TOWN OF DAVIE

TOWN COUNCIL AGENDA REPORT

SUBJECT: Resolution, Delegation Request: DG 6-3-08, Young World Plat

TITLE OF AGENDA ITEM: AMENDMENT - A RESOLUTION OF THE TOWN OF DAVIE, FLORIDA, AUTHORIZING AN AMENDMENT TO THE NON-VEHICULAR ACCESS LINE (NVAL) ON THE PLAT KNOWN AS "YOUNG WORLD PLAT," AND PROVIDING AN EFFECTIVE DATE. (DG 6-3-08, Young World Plat)

SKETCH AND DESCRIPTION
PLATTED NON-VEHICULAR
ACCESS LINE
PARCEL "B", YOUNG WORLD
SHEET 1 OF 2 SHEETS

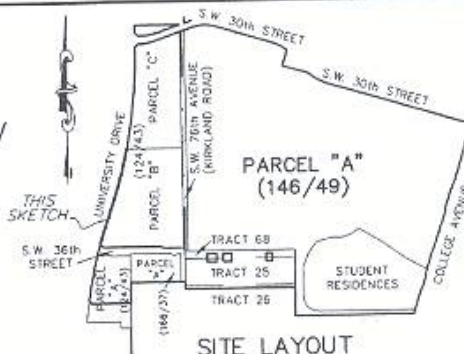
1. Relocate the 100' opening to be located approximately 710" north of Southwest 36th Street and restrict said opening to right-in, right-out, and left in only;
2. Close the existing 50' opening on University Drive that is restricted to right turns only; and
3. Close the 60' opening on Southwest 35th Street which restricted to right turns only.

SKETCH AND DESCRIPTION PLATTED NON-VEHICULAR ACCESS LINE PARCEL "B", YOUNG WORLD SHEET 2 OF 2 SHEETS

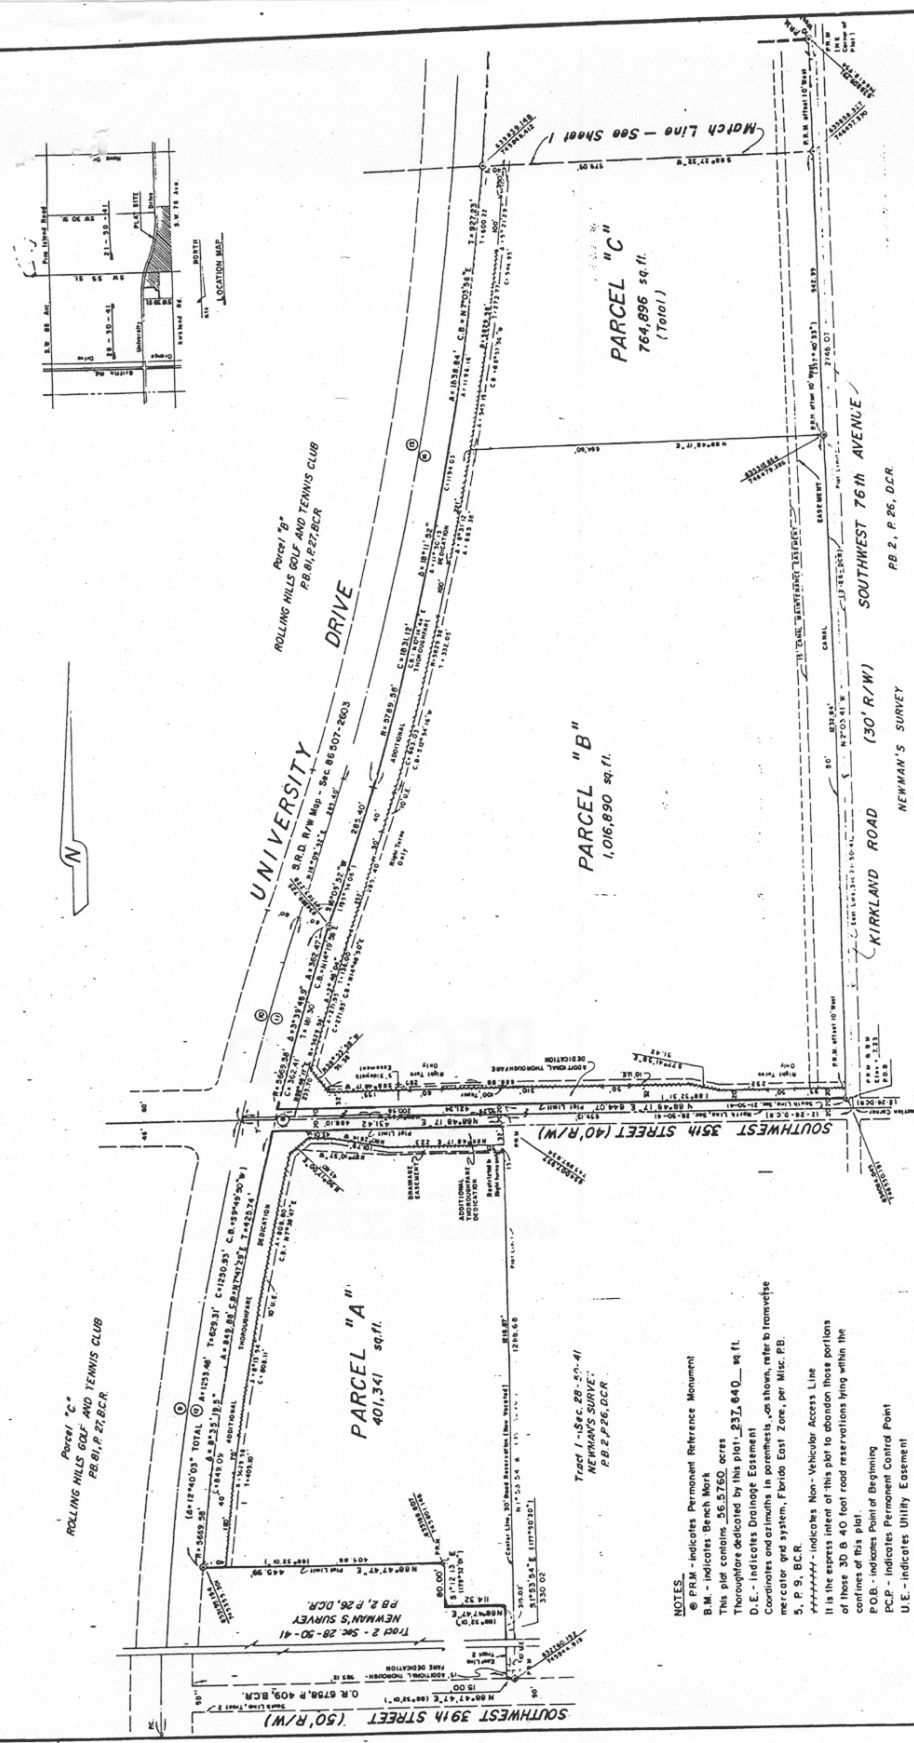
Beginning at the most Westerly Southwest corner of said Parcel "B", being the Point of Beginning (1) of a Non-Vehicular Access Line, being a point on a curve; thence Northerly on said Non-Vehicular Access line and on said curve to the right, whose radius point bears South 76°51'59" East, with a radius of 5,629.58 feet, a central angle of 02°46'05", an arc distance of 271.96 feet to a point of tangency; thence North 15°54'06" East, on said Non-Vehicular Access Line, a distance of 152.00 feet to the Point of Termination (1) of said Non-Vehicular Access Line and to the Point of Beginning (2) of a 50 foot Access Opening (restricted to right turns only); thence continuing North 15°54'06" East, on said 50 foot Access Opening, a distance of 50.00 feet to the Point of Termination (2) of said 50 foot Access Opening and to the Point of Beginning (3) of a Non-Vehicular Access Line; thence continuing North 15°54'06" East, on said Non-Vehicular Access Line, a distance of 83.40 feet to a point of curve; thence Northerly on said Non-Vehicular Access Line and on said curve to the left, with a radius of 5,829.58 feet, a central angle of 03°21'54", an arc distance of 342.38 feet to the point of Termination (3) of said Non-Vehicular Access Line and to the Point of Beginning (4) of a 100 foot Access Opening; thence continuing Northerly on said 100 foot Access Opening and on said curve to the left, with a radius of 5,829.58 feet, a central angle of 00°58'58", an arc distance of 100.00 feet to the Point of Termination (4) of said 100 foot Access Opening and to the Point of Beginning (5) of a Non-Vehicular Access Line; thence continuing Northerly on said Non-Vehicular Access Line and on said curve to the left, with a radius of 5,829.58 feet, a central angle of 02°10'20", an arc distance of 221.00 feet to the Northwest corner of said Parcel "B" and to the Point of Termination (5) of the herein described West line of Parcel "B".
